Attachment C - The Roads and Maritime Services Comments

SECTION 96(2) APPLICATION 100-2012/B – LOT A DP 33538, LOT 2 DP 739287 AND LOT 1 DP 774149, 111 CAMPBELL STREET, 50 CANBERRA AVENUE AND 18 GEORGE STREET, QUEANBEYAN – CHANGES TO BUILDING HEIGHT, LOCATION AND INTERNAL CONFIGURATION

From: LISSENDEN Andrew [<mailto:andrew.lissenden@rms.nsw.gov.au>]
Sent: Monday, 27 February 2017 8:34 AM
To: Mary Kunang <Mary.Kunang@qprc.nsw.gov.au>
Cc: Council Mailuser <Council.Mailuser@qprc.nsw.gov.au>; peter@hsarchitects.com.au
Subject: RMS comments on applicants additional information for DA 100-2012/B, 111 Campbell St Queanbeyan (RMS Ref: STH12/00084/06)

RE: RMS COMMENTS ON APPLICANTS ADDITIONAL INFORMATION FOR DA
100-2012/B, 111 CAMPBELL ST QUEANBEYAN (RMS REF: STH12/00084/06)

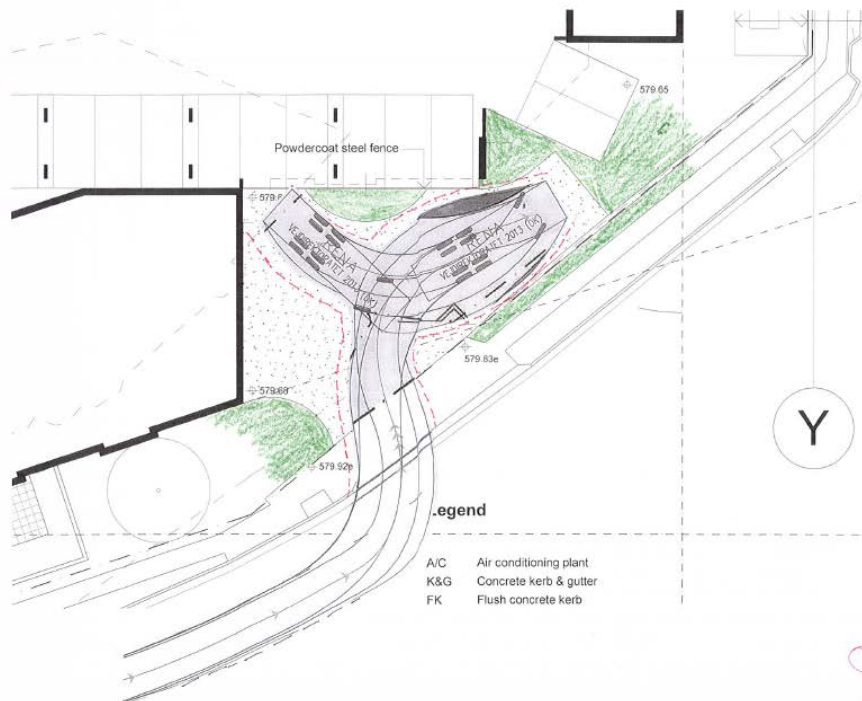
1. The additional information provided by the applicant makes no amendments to Drawing DA06 and DA07 to address the manoeuvring area concerns previously raised by the RMS in its letter dated 8 February 2017 (refer to Attachment 1). The RMS in providing its previous advice has undertaken a turning path assessment (refer to Attachment 2) which has determined that as per the requirements of the existing development consent the eastern driveway/loading area is unable to cater for a 9.9m vehicle without crossing outside the provided driveway area or impacting upon the building. It is also important to note that the plans submitted with the S96 application do not provide the required clearances to the swept path in accordance with Austroads Design Vehicles and Turning Path Template Standards. Any turning path plans submitted must include these clearances. RMS is concerned that if a vehicle is unable to properly use this area it may adversely impact upon the adjoining classified road; and

Please find attached a cut and paste with your turning path on our amended paved area.

It would appear there is now sufficient room.

Is it sufficient for us to send an amended pdf for you to overlay again?

Or do we need to get our traffic consultant involved?

Figure 1 Swept Path and Design Vehicle Specification

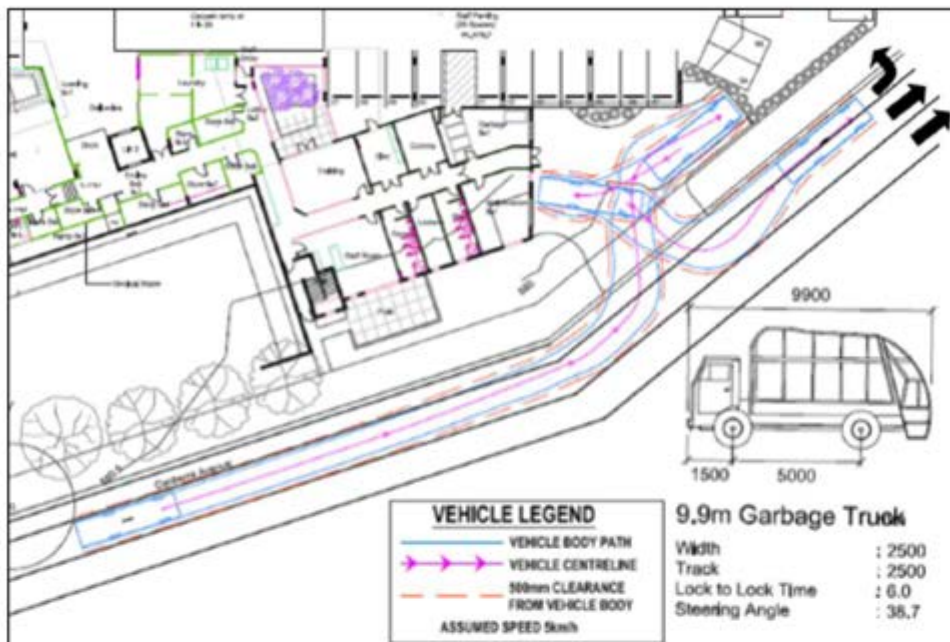
'The additional information provided by the applicant makes no amendments to Drawing DA06 and DA07 to address the manoeuvring area concerns previously raised by the RMS in its letter dated 8 February 2017 (refer to Attachment 1). The RMS in providing its previous advice has undertaken a turning path assessment (refer to Attachment 2) which has determined that as per the requirements of the existing development consent the eastern driveway/loading area is unable to cater for a 9.9m vehicle without crossing outside the provided driveway area or impacting upon the building. It is also important to note that the plans submitted with the S96 application do not provide the required clearances to the swept path in accordance with Austroads Design Vehicles and Turning Path Template Standards. Any turning path plans submitted must include these clearances. RMS is concerned that if a vehicle is unable to properly use this area it may adversely impact upon the adjoining classified road'

In response to RMS comments, Cardno has undertaken a swept path assessment of a 9.9m refuse collection truck accessing the eastern driveway / loading area. The 9.9m refuse vehicle has been assessed using AutoCad AutoTURN with a 500mm clearance. Figure 1 shows the swept path of the design vehicles and the design vehicle specifications.

The assessment indicates the truck is able to manoeuvre into the loading area and perform a three-point manoeuvre to exit without the 500mm clearance envelope crossing outside the provided driveway area or encroaching into the building. It must be noted that the refuse collection truck clearance envelope crosses into the right lane as indicated in the swept path above.
